Job Ref: B3602-A8-DA26

**Response to Information Request– 69-73 Kraft Rd, 136-152 Laxton Rd & part 26 Trivior Street, Pallara QLD 4110  
– Council Ref: A006935362**

We refer to Council's Information Request dated 9 March 2026 regarding the abovementioned application.

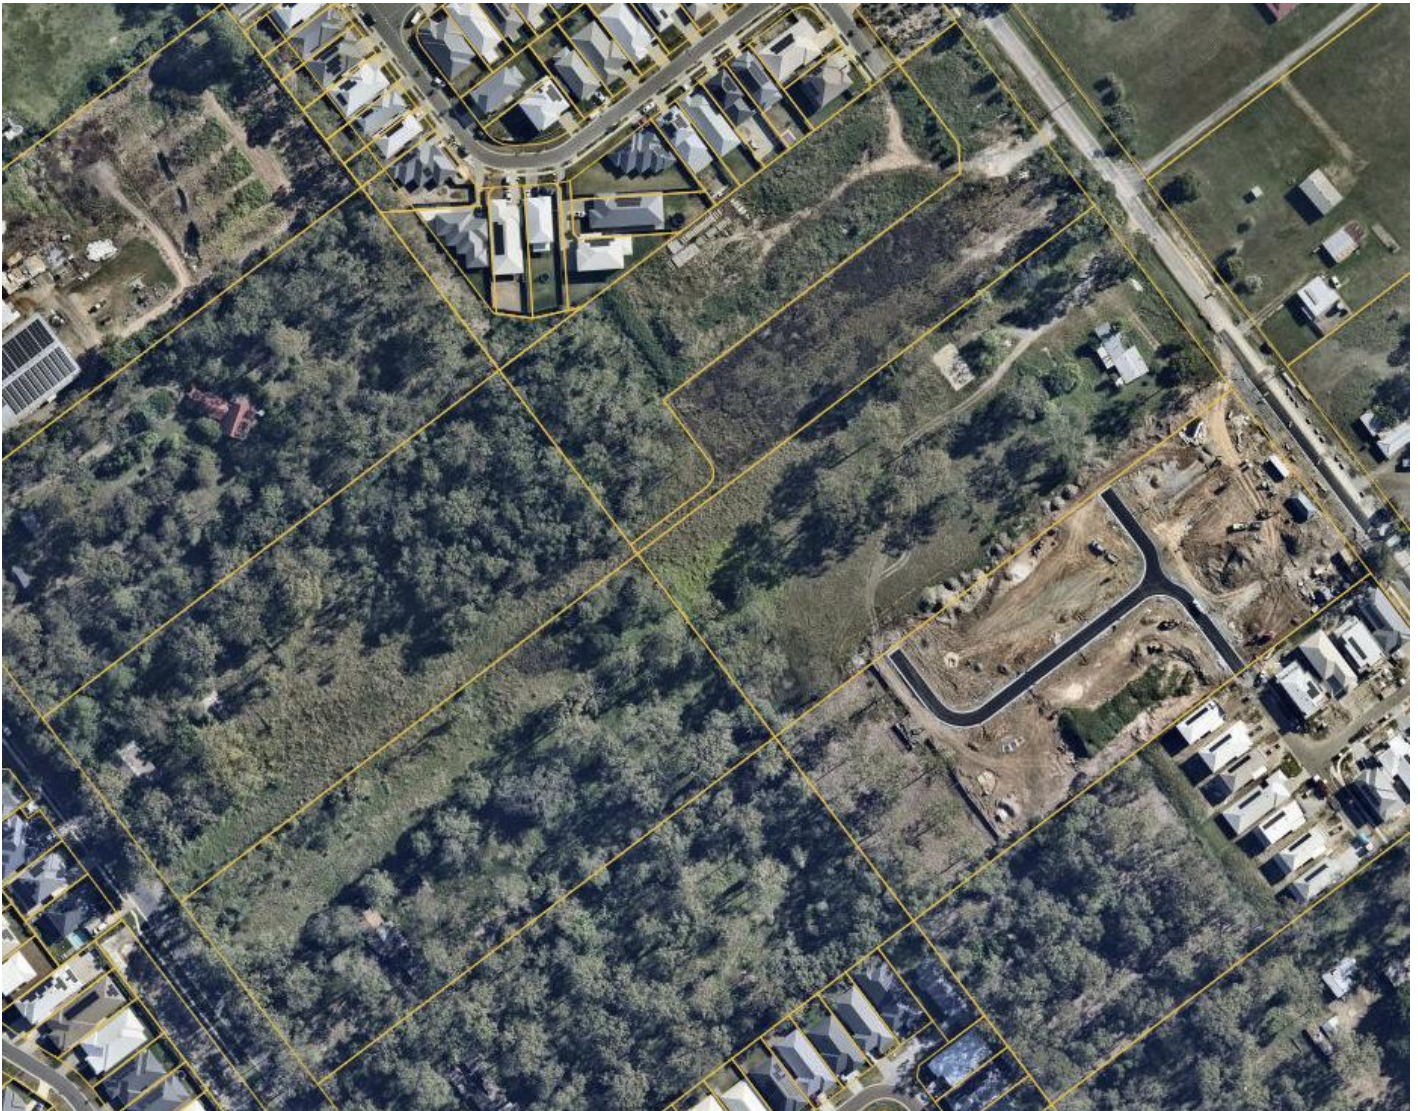
7. Temporary access easements and manoeuvring areas will be required at the interim terminations of the new road to the south (around lots 9, 10 and 26) if the local roads approved in the adjoining development (Ref: A006728398) have not been constructed to allow the Refuse Collection Vehicle (RCV) to circulate.
  - a. Provide amended plans in accordance with PO19 of the TAPS code that show a temporary turn around areas for RCV along Road 2 & 3, along with swept path drawings demonstrating compliant manoeuvring through the temporary turn around area.

We note that the adjoining development to the east (A00) is currently under construction as demonstrated in the below Nearmap imagery taken on April 2026:

We anticipate that construction of the development will continue to progress and be completed shortly. Should Council consider it necessary and if the Applicant has not undertaken plan sealing once the proposed development is approved, conditions can be imposed and plans marked up requiring temporary turnarounds over proposed lots 8 or 11 and 25, ensuring all vehicle manoeuvring occurs in the subject site. It is acknowledged that this requirement will be unlikely.
